**Section 75W Modification Request
Bungarribee Industrial Estate, Huntingwood West Precinct
Stage 5B Bulk Earthworks - Project Approval MP08_0225 MOD2**

Director-General's
Environmental Assessment Report
Section 75W of the
Environmental Planning and Assessment Act 1979

September 2013

Figure 8: Proposed modified cut and fill Levels to facilitate Council DA warehouse (Green rectangle – RL 49.4) and under croft car parking (Orange rectangle - RL 46.30 to RL 45.77)

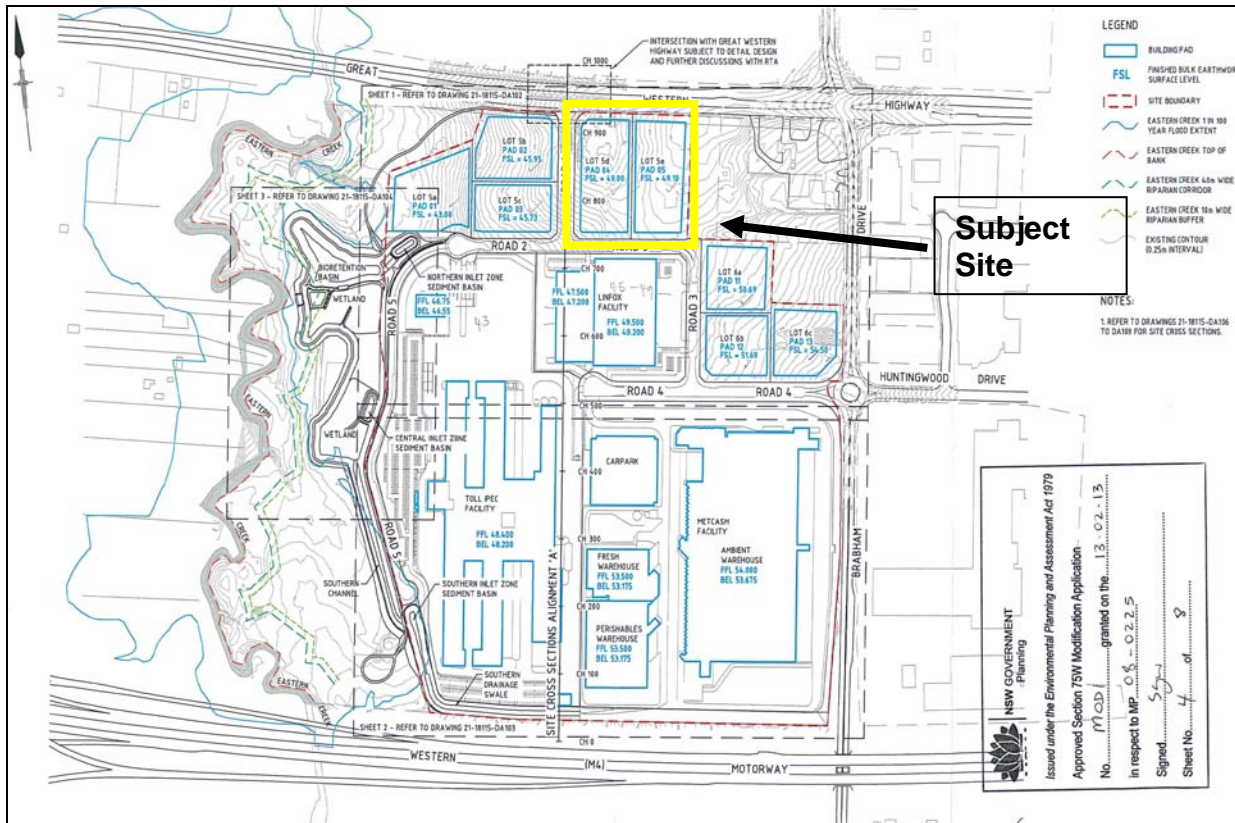
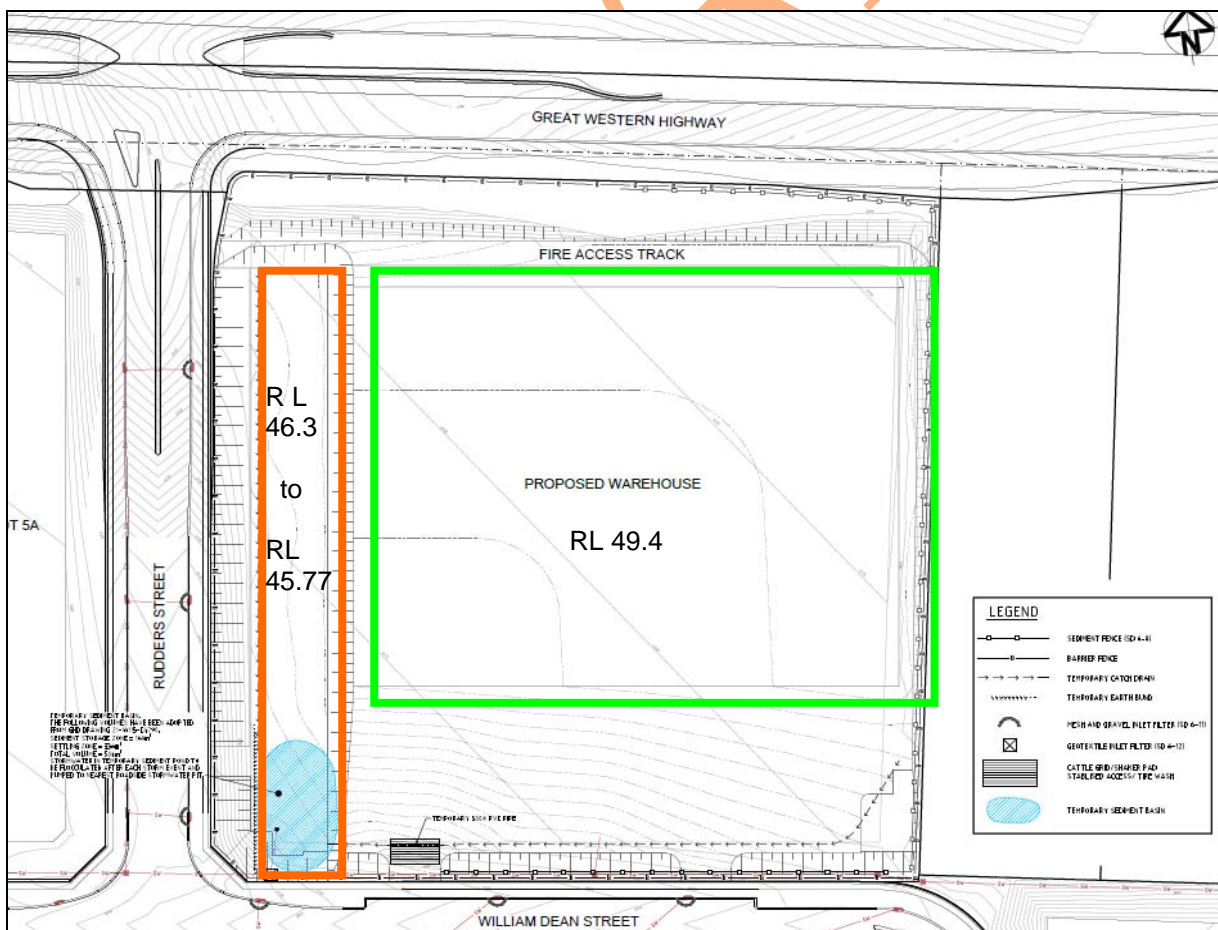
The proposed modification would increase the approved pad levels of the site (which currently range between RL 49.00 and RL 49.10) to RL 49.40 at the location of the future warehouse building, and reduce the levels at the location of the future undercroft car parking area, adjacent to the western boundary of the site, to a range between RL 46.30 and RL 45.77 (Refer to **Figure 8**, over). The proposed RL 46.30 to 45.77 cutting will drain to a temporary sediment basin in the south western corner of the site, designed to ensure all stormwater runoff is contained on the site.

Batters are to be provided to create the level change around the perimeter of the site, allowing for future vehicle cross-overs, with an additional internal batter to the RL 46.30 to 45.77 cutting. No retaining walls are proposed as any required structures form part of the development application to the Council.

The proposed level of RL 49.4 is similar to the approved levels for Lot 5B of RL 49.00 and RL 49.10, and would result in an additional 0.3-0.4 metres of fill over the portion of the site intended to accommodate the future warehouse building. The proposed gentle slope to RL 47.4 at the southern boundary is designed to ensure that heavy vehicular access is available from the vehicle cross-overs on William Dean Street. The proposed RL 46.30 to RL 45.77 adjacent to the western boundary represents a 2.70 to 3.23 metres decrease from the approved RL 49.00 level in the western portion of the site, and is necessary to facilitate future undercroft car parking. The proposed temporary sediment basin in the south-western corner of Lot 5B, together with the cut adjacent to the western boundary is designed to ensure that all stormwater run-off is contained within Lot 5B until such time as a permanent stormwater drainage system is established.

The Department is satisfied that the proposed levels are in keeping with the original approval and will not result in any adverse impacts. Accordingly, the Department does not raise any objection to the proposed development pad levels and other proposed bulk earthworks.
